## Ground - Ignition Plate

Force 75, 90 & 120 HP - 1996 thru 1998  
Serial Number - 0E138600 thru 0E329500

Sport Jet 95XR/120XR - 1996 thru 1998  
Serial Number - 0E141089 thru 0E329500

57211

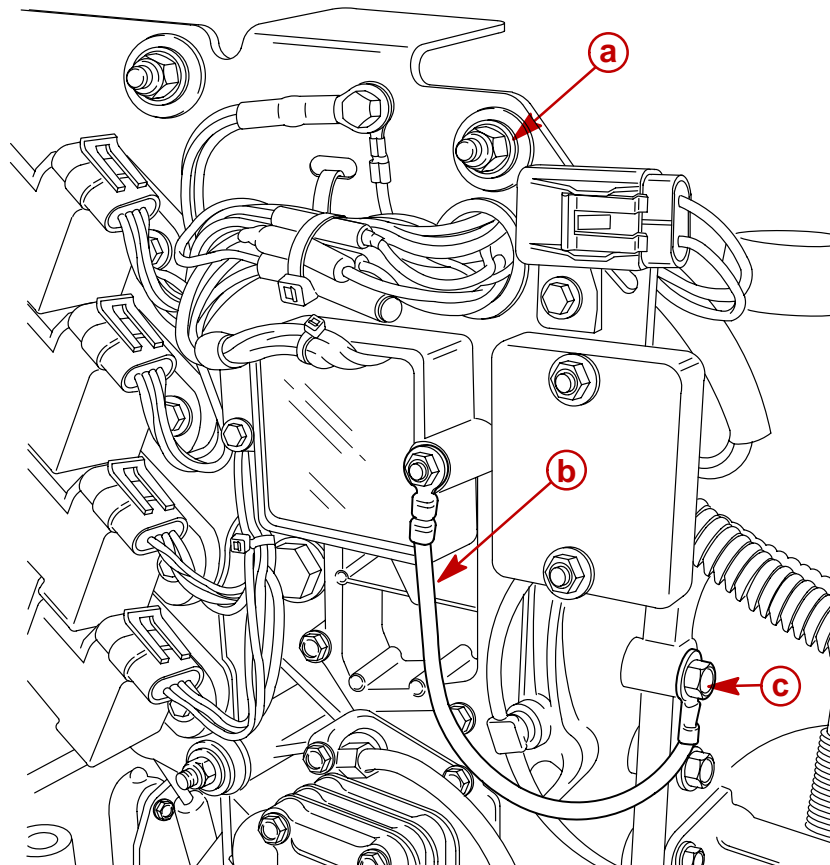
A poor ground connection from the ignition components plate to the engine block can cause a voltage regulator and/or multiple CDM failures.

- a** - Old Ground Connection
- b** - New Ground Wire
- c** - New Ground Connection

To ensure a good ground connection, a new ground wire and routing has been developed. This was incorporated as a running change during the 1998 model year and can be applied to the engines within the serial number range listed above. The figure below indicates the proper routing of the ground wire.

The part number of the ground wire is: 84-856583A1

**IMPORTANT: Remove the original ground wire (voltage regulator to ignition component plate stud) before attaching the new ground wire. This ensures proper thread engagement of the screw.**
